From: Barber.Joshua@epamail.epa.gov
Sent: Wednesday, October 31, 2007 12:45 PM
To: janna.staszak@ch2m.com; Burchette.John@epamail.epa.gov;
kimberly.henderson@ch2m.com; kmdoran@deq.virginia.gov; Reisch, Timothy A CIV
NAVFAC MID ATLANTIC
Cc: Barber.Joshua@epamail.epa.gov
Subject: Draft Technical Memorandum-Addendum to the Expanded Remedial Investigation/Human
Health Risk Assessment/Ecological Risk Assessment for Site 5; St. Juliens Creek Annex

EPA has completed its review of the subject document and submits the following comments at this time:

Figure 3-9
 Site 5 and 6 Subsurface Soil Sample Locations
 St. Juliens Creek Annex
 Chesapeake, Virginia

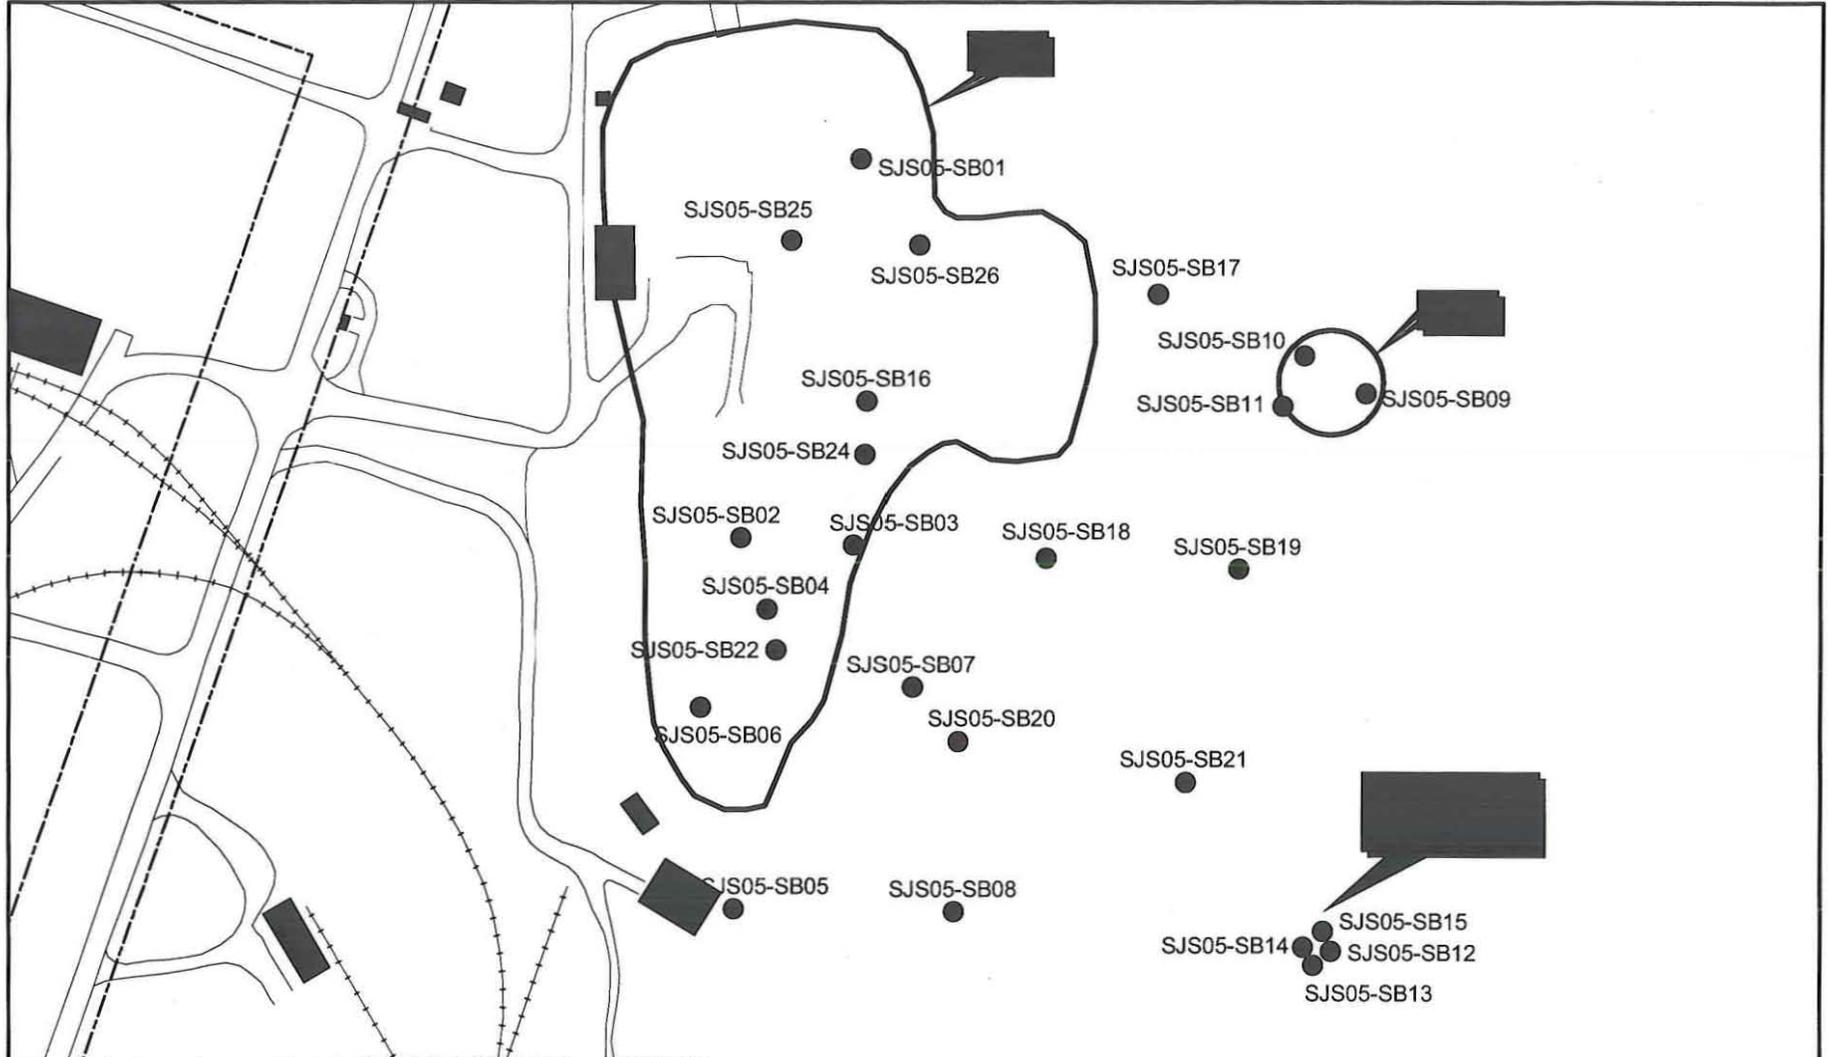
- The two monitoring wells located downgradient of the Waste/Burnt Soil area consistently contained the highest levels of Al and Mn. A statistical comparison of the subsurface soil detections in the proximity of these two wells, e.g. samples SB05, SB07, SB08, and SB20 found in the attached figure, could provide additional evidence that the levels of Al and Mn in the shallow groundwater may be related to natural soil conditions at the site.
